PG&E Letter DCL-10-133

Docket No. 50-275, OL-DPR-80
Docket No. 50-323, OL-DPR-82
Diablo Canyon Units 1 and 2

Response to NRC Letter dated September 29, 2010, Summary of Telephone Conference Call Held on August 31, 2010, Between the U.S. Nuclear Regulatory Commission and Pacific Gas and Electric Company Concerning Responses to Requests for Additional Information (Sets 2 and 13) Related to the Diablo Canyon Nuclear Power Plant, Units 1 and 2, License Renewal Application

CST Schematic (U1 and U2) with Nozzle numbers

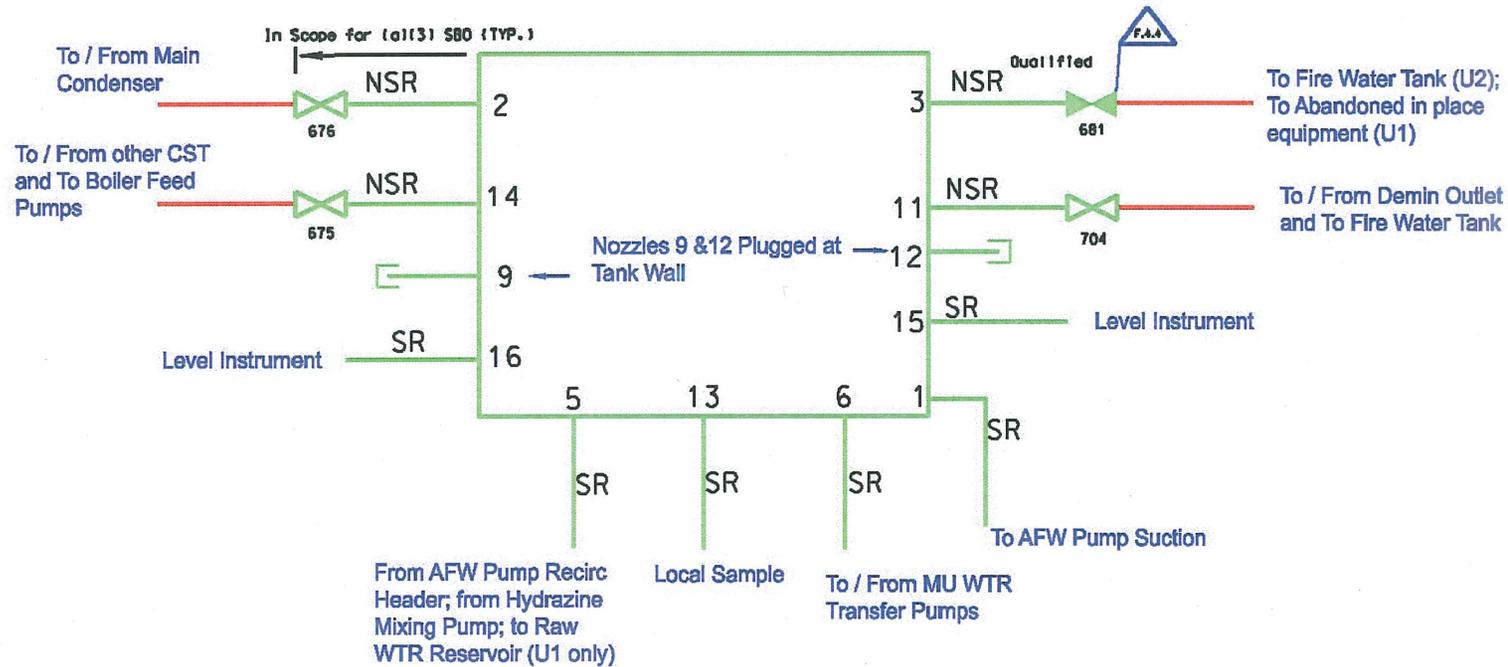
In its August 17, 2010, response to RAI 2.3.3.5-4, the applicant provided an explanation for their selection of endpoints for various license renewal boundaries. However, the staff was unclear how the seismic anchors for non safety-related connections to the condensate storage tank, firewater storage tank, and primary storage tank were established.

The CSTs are shown on two boundary drawings, LR-DCPP-16-106716-16 (U1 CST) and LR-DCPP-16-106716-17 (U2 CST). See Enclosure 3 for the CST schematic diagram which shows the lines connected to the CST. The schematic diagram shows: (1) CST nozzle numbers, (2) SR and NSR lines connected to the CSTs, (3) the extent of connecting lines in scope for (a)(3), and (4) the function of each connected line. A note has been added to Boundary Drawings LR-DCPP-16-106716-16 and LR-DCPP-16-106716-17 to clarify that the NSR lines attached to the modified plenum nozzles of the CSTs do not require equivalent anchors.

As discussed in the response to RAI 2.3.3.5-02 (PG&E Letter DCL-10-104 dated August 17, 2010) internal plenums are installed around any nonseismically qualified tank connections in the required usable volume region. There are a total of four Diablo Canyon Power Plant Class II / Category II NSR lines attached to the CST at nozzles 2, 3, 11 and 14. Internal plenums are installed on CST nozzles N2, N11, and N14 (reference Line Valves 676, 704, and 675 respectively). The plenums preclude the need to extend the boundary of the seismic evaluation on the connected NSR lines beyond the tank nozzles. This constitutes an exception to the guidance provided in NEI 95-10, Appendix F, Revision 6, for equivalent anchors on NSR piping attached to SR systems, structures, and components. The CST plenums are a plant-specific design feature to ensure that the usable volume of the CST is maintained even if NSR attached piping were to fail. The NRC has approved this modified design (Reference Amendment No. 204 to Facility Operating License No. DPR-80 and Amendment No. 205 to Facility Operating License No. DPR-82 for the Diablo Canyon Power Plant, Unit Nos. 1 and 2, dated March 30, 2009) recognizing that NSR piping attached to the tank could fail and that if it did fail it would not adversely affect the SR intended function of the tank. Therefore, taking exception to the NEI guidance is considered acceptable based on a plant-specific design feature that is approved by the NRC.

CST nozzle 3 was not modified to increase the usable reserved inventory of the CSTs and does not have a Class I plenum attached. The line attached to Nozzle 3 has seismic bracing above and below the first isolation valve (MU-1-681 / MU-2-681). The entire line from nozzle 3 to the downstream support for the first isolation valve has been evaluated to demonstrate that the piping will withstand a seismic event without failure. Based on this evaluation, an equivalent seismic anchor exists at the valve location.

Green is (a)(1) or (a)(3)
 Red is (a)(2) Spatial Interaction
 SR is safety-related, Design Class I.
 Nozzles 2, 6, 11 and 14 have plenums. Nozzle 3 is connected to a Class II (NSR) line that has been evaluated to withstand a seismic event without failure.
